YUCCA MOUNTAIN SITE CHARACTERIZATION PROJECT

RESPONSES TO CALIFORNIA ENERGY COMMISSION COMMENTS ON THE SITE CHARACTERIZATION PLAN

DECEMBER 1990

Figure 3-2.

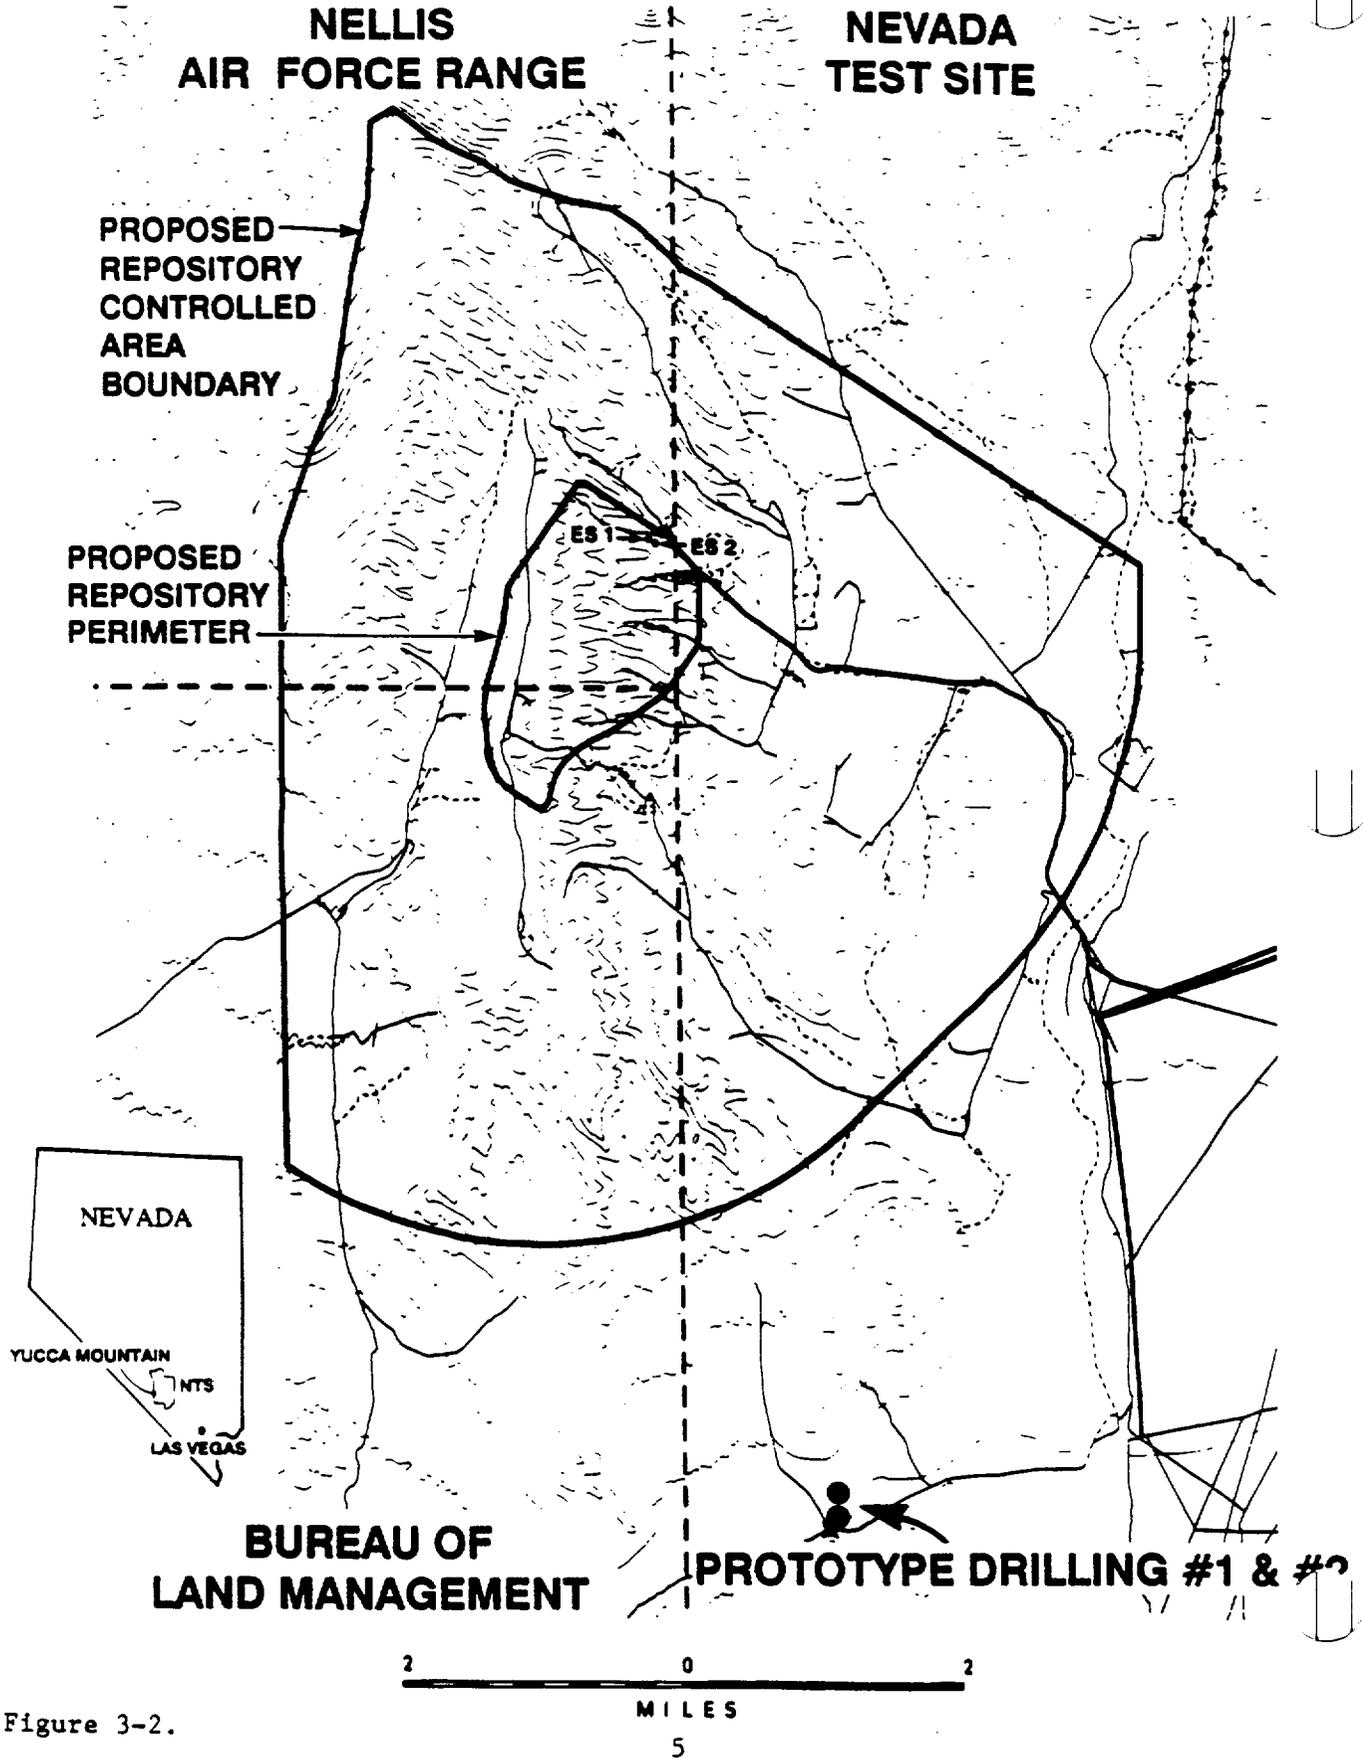
Not all figures show the repository location. Each figure should depict this location. Without this information, it is difficult to place the Repository in relation to the natural and man-made features which have been discussed throughout the Overview. Staff was not able to ascertain the relative location for the exploratory shafts to be dug in relation to the proposed Repository. It is difficult to determine if the location for this testing is close enough to the proposed Repository site to test the same depositional environment, but far enough to prevent creating a potential conduit for ground water into this same Repository. We would be happy to complete the evaluation when the figures are amended.

The Site Characterization Plan (SCP) Overview presents summaries of selected topics covered in depth in the SCP; it is not a substitute for the SCP. The Overview is intended primarily for those persons who want to understand the general scope and basis of the Department of Energy's (DOE) site characterization program, the activities to be conducted, and the type of facilities that would comprise a hypothetical repository at Yucca Mountain, without spending the time necessary to become familiar with all of the technical details in the SCP. DOE agrees that the criticism is justified in regard to the figure(s) and hopes the enclosed figures (3-2 and 3-3) together provide information enabling the reader to place the Exploratory Shaft Facility (ESF) locations in relation to the repository perimeter drift (line surrounding "Underground Facility" in Figure 3-2), and in relation to the boundaries of land controlled by the Nevada Test Site, the Air Force, and the Bureau of Land Management (Figure 3-3). ESF specific locations are currently under study in the ESF Evaluation.
